The review team have worked independently of SCC officers to identify if there are any problems or issues with the proposed scheme in the context of the targeted concern listed above. Based on the information provided, this technical review considers whether the proposed active travel scheme would be better than the existing situation for pedestrians and cyclists.

Section 1 of the A3100 scheme is partially constrained by the non-availability of publicly-owned land. In response to SCC's public engagement, this technical note reviews the safety of the short length of the scheme where constraints mean that 1.8m width shared use paths are proposed.

© sketched based on Bing Maps  
 Figure 2 Extent of narrow shared use path

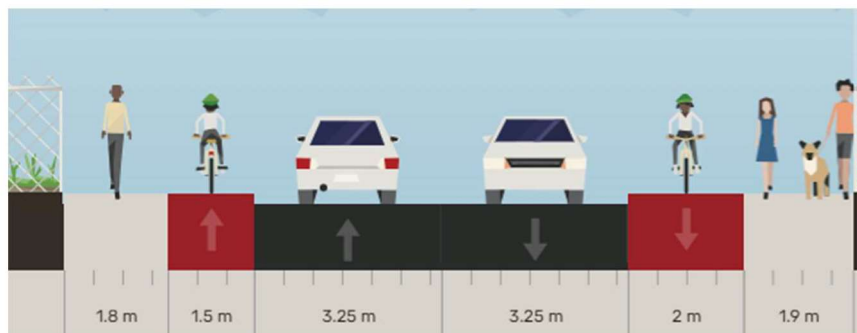
- i. Northbound for approximately 45m between ch 0+460 and 0+505; minimum width 1.8m.
- ii. Southbound for approximately 39m between ch 0+505 and 0+466; minimum width 1.8m.

The narrow shared use paths apply to two lengths both of which are shorter than 50m. With up to 147 pedestrians and about 30 cyclists an hour, and even allowing for growth in numbers, usage of these two sections is relatively low and users should only experience occasional conflict.

© sketched using Streetmix.net  
 Figure 3 Typical cross-section

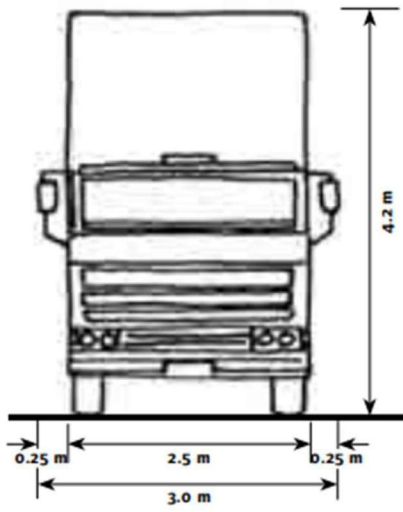
Figure 3 **Error! Reference source not found.** shows a typical cross-section along the scheme.

As noted above, the proposed trafficked lane widths adjacent to the sections of narrow shared use paths are each 3.25m.

Figure 4 Road users and widths

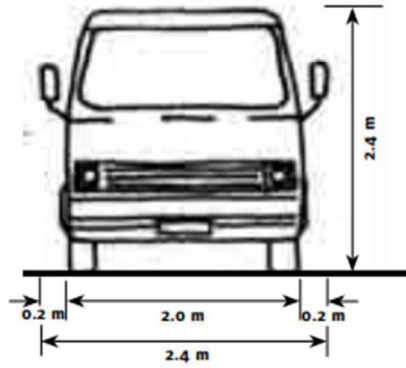
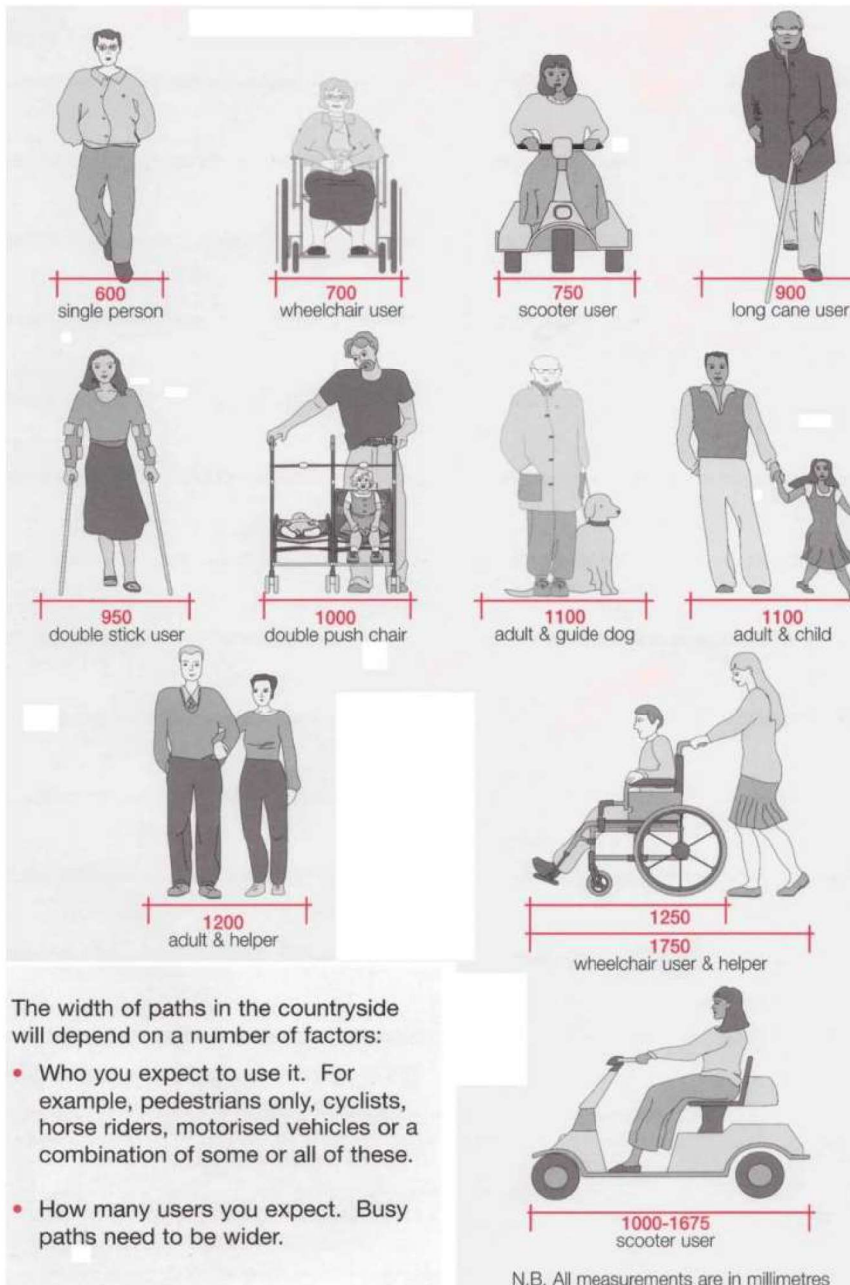
Figure 4 shows typical vehicle dimensions. The maximum width of a vehicle in the UK is 2.55m, although there are exceptions such as refrigerated lorries. Cars are typically 1.8m width but new cars such as sports utility vehicles (SUVs) can be wider.

In the UK, design vehicles include cars, refuse vehicles, buses and articulated lorries. HGVs and buses are the widest with an assumed 2.55m width although this does not account for elements such as wing mirrors that extend out from the vehicle body (figure 4 refers). Including wing mirrors indicates an overall vehicle width of approximately 3.0m.

Based on the figures above, opposing HGVs/buses would be able to pass with 350mm clearance between each HGV and the nearside kerb if they are centred in their lane:

3.25m lane – 2.55m HGV excluding wing mirrors = 0.70m clearance in total for each lane

$0.70/2 \approx 0.35\text{m}$  on the nearside of each HGV ( $\approx 0.70\text{m}$  between vehicles)

The clearance falls to 125mm considering wing mirrors:

3.25m lane – 3.00m HGV including wing mirrors = 0.25m clearance in total for each lane

$0.25/2 \approx 0.125\text{m}$  on the nearside of each HGV ( $\approx 0.25\text{m}$  between vehicles)

This indicates that two HGVs can pass each other safely without their wing mirrors encroaching on the shared use path.

© The Fieldfare Trust :Ltd  
 Figure 5 Pedestrian users and widths

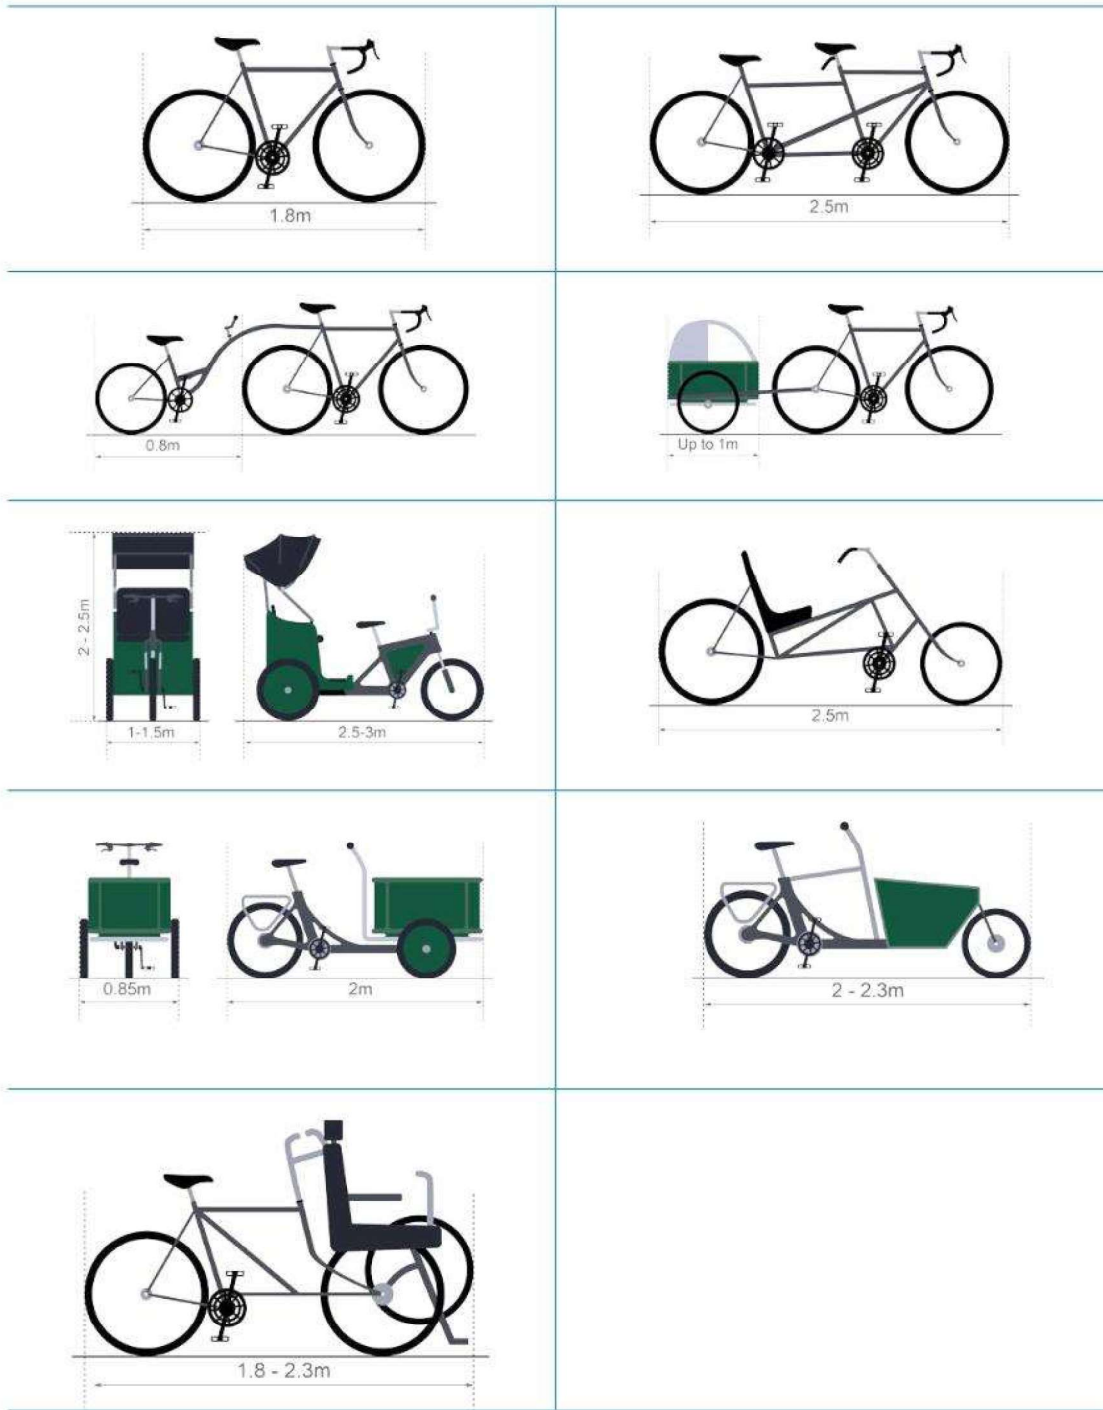
Footways need to be wide enough for pedestrians to pass one another and keep clear of edge boundaries. Figure 5 shows diverse types of users and the widths needed to comfortably navigate a pedestrian facility.

The proposed shared use path is a minimum of 1.8m and adequate for two adults walking side-by-side or for a double buggy including additional elbow room. It is also wide enough such that a wheelchair user and a pedestrian can pass one another. Therefore a 1.8m width is acceptable in principle to accommodate the needs of a diverse range of pedestrians.

Figure 5**Error! Reference source not found.** sets a 0.6m width for a single pedestrian and 0.7m for a wheelchair user. An additional 0.2m to facilitate users passing each other gives the minimum 1.5m width stated in *Inclusive Mobility*<sup>**Error! Bookmark not defined.**</sup> ( $0.6\text{m} + 0.7\text{m} + 0.2\text{m} = 1.5\text{m}$ ).
